Letter to DPI-Water

17 January 2018

**Bylong Coal Project Response to PAC Review Report
NSW Department of Primary Industries – Water Issues**

**Bylong Coal Project EIS
Response to Department of Primary Industries Submission, Dated 7 November 2016**

Figure 1
Predicted Groundwater Inflow/Seepage into Mining Areas

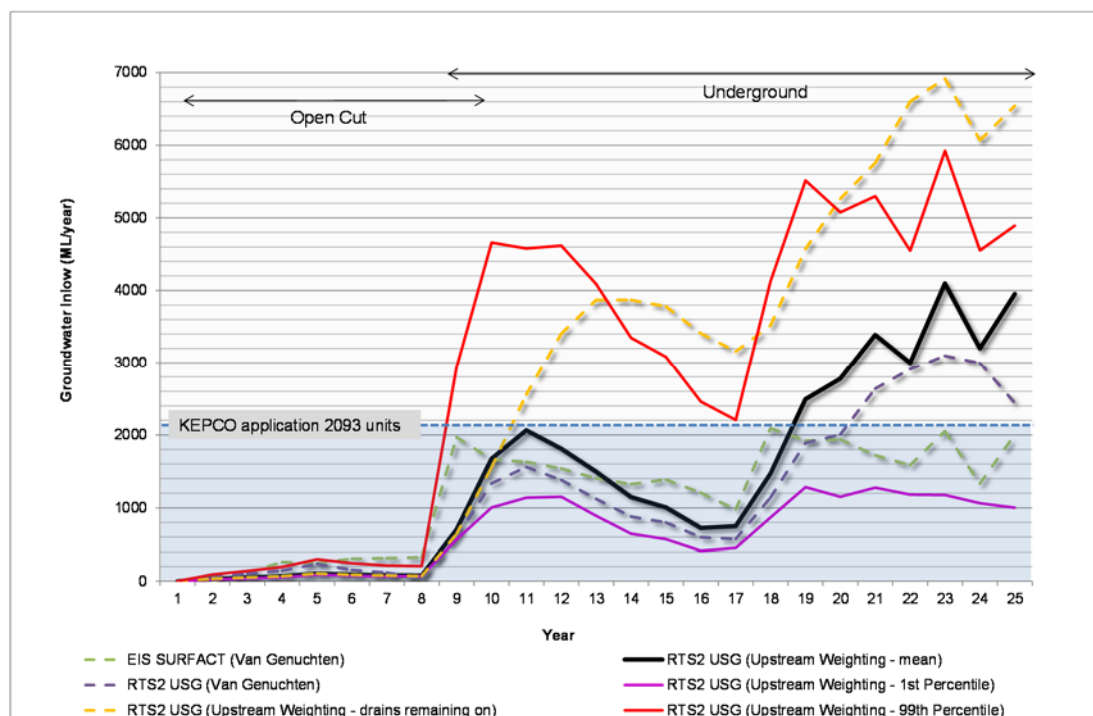
The current prediction for groundwater take requirements from the Sydney Basin-North Coast Groundwater Source is 4100 ML. As the proponent currently holds Water Access Licenses (WALs) for 411 shares and has a valid application equivalent to 2093ML the proponent may need to purchase 1596 shares from the market to make up the shortfall.

In the case that DPI-Water is unable to amend the current water licence application, it is noted that the current application (i.e. 2,093 ML) will cater the Project's predicted demands based on the base case scenario (RTS2 USG (Upstream weighting – mean)) until Project Year 19.

Therefore, it is likely that the additional water shares (up to the 4,099 ML of groundwater inflow predicted for Project Year 23) may be able to be secured from other users within the water source prior to these impacts occurring.

Figure 1 shows the various scenarios predicted by the numerical model in relation to the water licence application for 2,093 ML. It highlights for the base case (RTS2 USG (Upstream weighting – mean)), the mine can operate until Project Year 19 without needing to obtain additional water license units. It is also noted that the groundwater model predictions will be able to be further validated and refined with real data throughout the initial years of mining operations. This process will improve the predictions for the later years of mining within the underground mining area and assist in confirming the maximum water access licence requirements under the North Coast WSP.

Figure 2
Predicted Base Case Water Take from the Bylong River Water Source

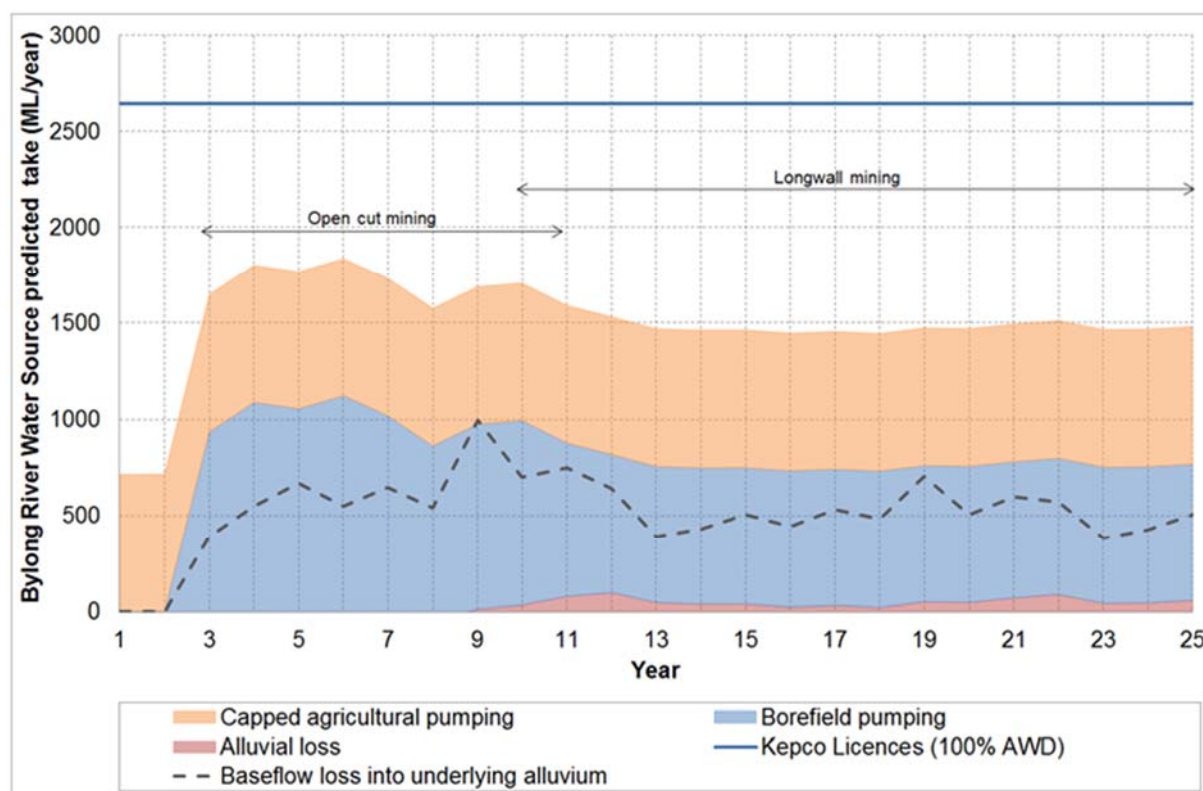
The proponent may not have correctly apportioned relevant take from each water source resulting from inflows to the mine, and may have underestimated the shares required in the Bylong River Water Source. The proponent holds 2535 shares in the Bylong River Water Source. It is understood that these shares will contribute to accounting for take of water from the bore field and take of water for agricultural purposes. However these shares will also need to account for passive take of water via alluvial loss and reduction in baseflow. For example the additional information received indicates that peak baseflow loss will occur in year 9 at 2.7 ML/day or 986 ML/year in the 99th percentile scenario. As such in that year this volume of water may not be actively extracted from the Bylong River Water Source and this should be reflected in the site water balance.

Figure 2, which is modified from the Supplementary RTS groundwater report (Appendix J of the Supplementary RTS), shows the direct and indirect water takes from the Bylong River Water Source compared to the water licences held by KEPCO. **Figure 2** illustrates the:

Figure 2 clearly illustrates that the water licences held by KEPCO for the Bylong River Water Source account for both the direct and indirect water takes resulting from the Project. The dashed line in **Figure 2** shows the baseflow loss from the surface water systems induced by the indirect and direct take from the alluvial aquifer. It is important to understand that this line does not necessarily represent flow from the surface systems into the underlying alluvial aquifer. Rather it is calculated as the difference in flow between the two models with and without mining. It therefore represents a reduction in flow of groundwater discharging into the streams as baseflow due to the indirect and direct impacts.

Figure 4
Scatter Plot of Hydraulic Conductivity Measured Versus Modelled

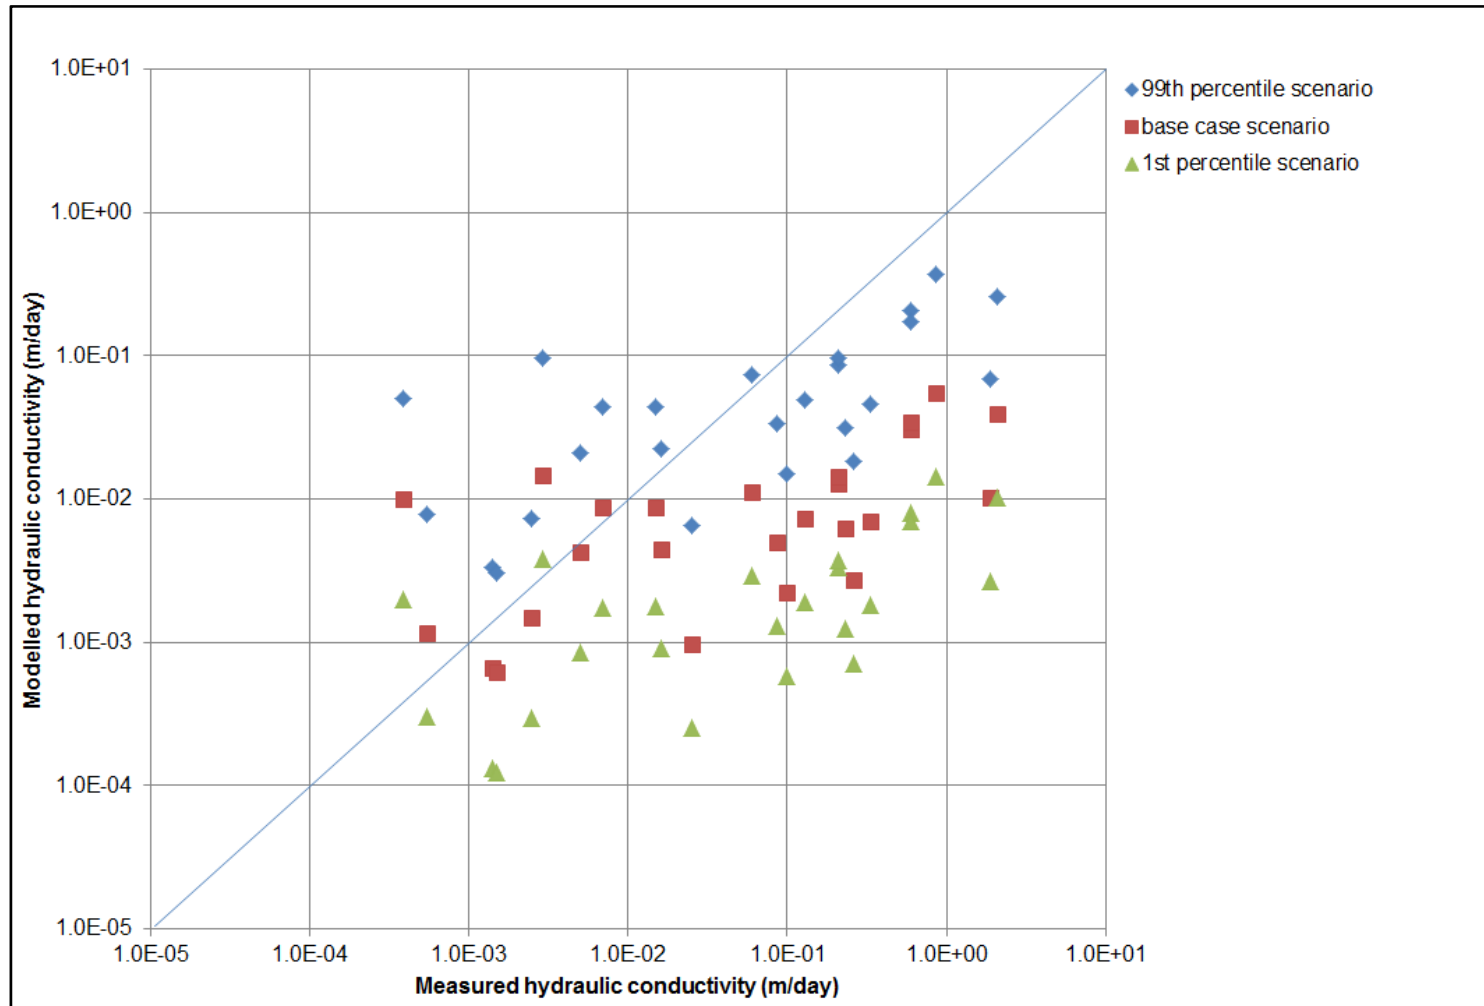
It is accepted that the Independent Model Review classed the model as fit for purpose however there are numerous elements which result in a lack of certainty regarding the impacts of the proposed project. Hence the recommendation for an alternative modelling code to be used as part of the Mining Operations Plan process. The reasons for this recommendation are as follows.

- The uncertainty analysis tested the influence of varying hydraulic conductivity values within the coal seams on the predicted impacts. **Table 1** presents the value of hydraulic conductivity measured using packer tests and the values adopted within the model in the uncertainty analysis for the various scenarios. The data is also presented graphically in **Figure 4**.

- **Table 1** and **Figure 4** show the range of hydraulic conductivity adopted within the uncertainty analysis covers the median hydraulic conductivity, but not the extremes of the field measurements. Ultimately the range adopted and considered appropriate is based on the experience of the modeller with complex numerical models. The modeller does not automatically assume that the point source testing through boreholes has correctly characterised the hydraulic properties of a large spatially varying region, but rather draws upon experience, particularly for greenfield sites and exercises some judgement to determine the most appropriate range in the aquifer properties to quantify uncertainty. In this case, the range was selected to exclude the extremes in the test results that would have resulted in many orders of magnitude difference in permeability between the Ulan and Coggan coal seams that was considered highly unlikely.

Figure 1 - Combined open cut mining area stored inventory

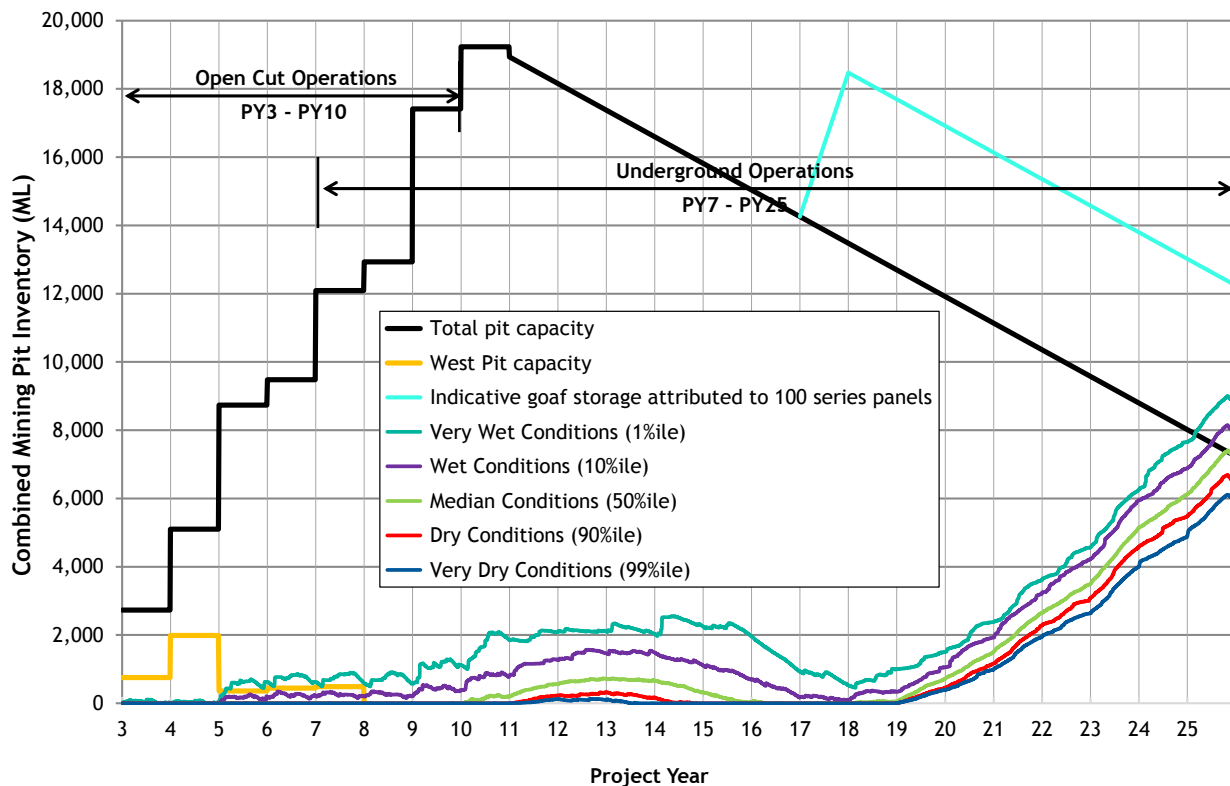
Please find below our response to the various surface water concerns for the Bylong Coal Project (the Project) which have been raised in the Planning Assessment Commission (PAC) Review Report (SSD 6367, 25 July 2017). This response should be read in conjunction with the EIS Surface Water Impact Assessment (WRM 2015a), the surface water sections of the Response to Submissions (RTS) (Hansen Bailey 2016a) and the surface water matters provided within the Supplementary Response to Submissions (Supplementary RTS) (Hansen Bailey 2016b).

Figure 1 shows an updated plot of the likely range of potential water storage volumes required in the open cut mining area to prevent spills from the mine water system, depending on climatic conditions. The results shown in Figure 1 are based on the revised groundwater inflows shown in Table 1, with inflows varied from year to year, rather than averaged across mine stages as assumed in the assessments from the EIS and the Supplementary RTS.

Figure 1 also shows the total water storage capacity of the open cut pits (mostly provided by East Pit), as well as indicative storage in the underground goaf (attributed to the 100 series longwall panels) which will be available from the latest PY 18. The reduction in water storage capacity over time from Year 11 is due to the placement of coal reject material within the open cut void such that at the end of underground mining it can be capped and rehabilitated. This will enable the entire open cut mining area being rehabilitated to a free draining landform and unlike most open cut mines will not comprise a final void.

Figure 1 shows that over most of the Project life, the available storage capacity within the open cut pits is significantly higher than the 1st percentile prediction (very wet conditions) of the required water storage volume. Even if very wet climatic conditions occur, the available storage volume at the very end of Project life exceeds the required storage volume by more than 3,400 ML. Once the 200 series longwall panels are extracted, the entire underground mine will become available for storage which will further increase the available storage volume.

Figure 2 - Sensitivity Case 1 results for stored water inventory (Revised runoff)

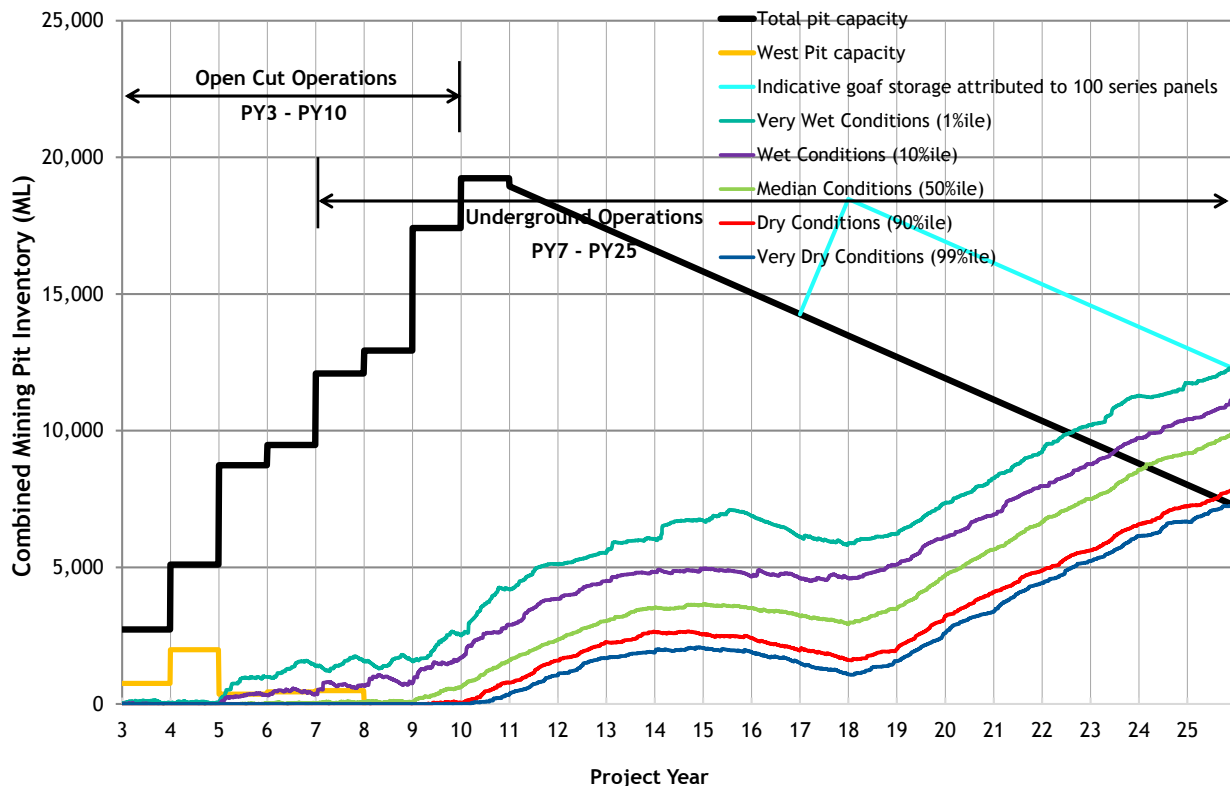
In response to a peer review of the water balance modelling completed within the EIS by Hydro Engineering & Consulting (HEC), an additional five water balance modelling cases have been assessed with different assumptions for surface runoff and groundwater inflows. The adopted cases are summarised in Table 2. The approach for selecting the sensitivity cases is described as follows:

The sensitivity results for the stored water inventories are shown in Figure 2 for the Revised Runoff sensitivity case (Case 1). The revised runoff parameters and groundwater inflows result in generally higher stored water volumes over the life of the Project when compared to the Supplementary RTS case. The available storage capacities (shown in Figure 2) would be sufficient to contain water volumes under this scenario over the Project life. As noted above, many years of mining operations will be available to validate the groundwater model and refine the groundwater inflows and the performance of the water management system and make any necessary changes to the sites water storage capacities to ensure the containment of mine water in the later years of the Project. In addition, inclusion of goaf storage for the 200 series longwall panels will provide additional storage capacity.
